PUR-1576

ADDENDUM NO. 1
INVITATION TO BID

BLACK ROCK CLUBHOUSE ROOF REPLACEMENT

Series 1500 1-1/2" Integral Snap-Lock

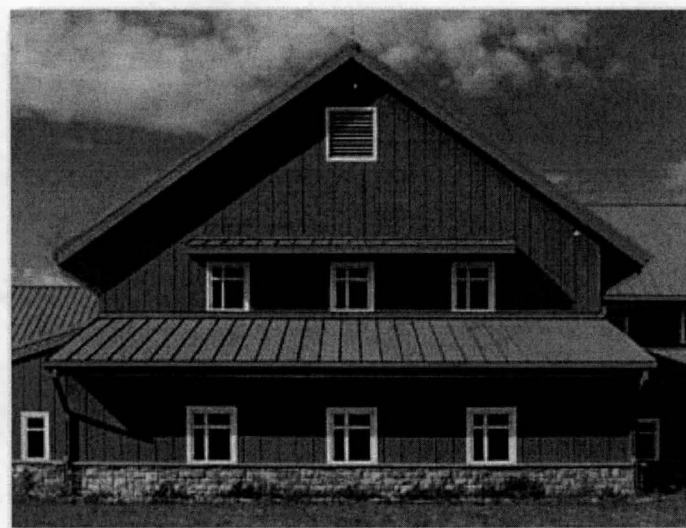
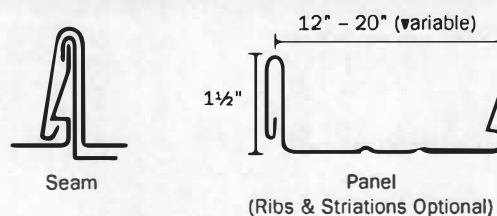
ITEM NO. 7: Inquiry: Will Englert A1500 snap lock architectural metal roofing system be

considered as an alternate. (See Attached spec sheet for the Englert A1500 Metal roofing system)

Response: Alternative Systems will be acceptable when meeting the minimum attributes of the specifications and when acceptable by Washington County. See attachment B of this addendum.
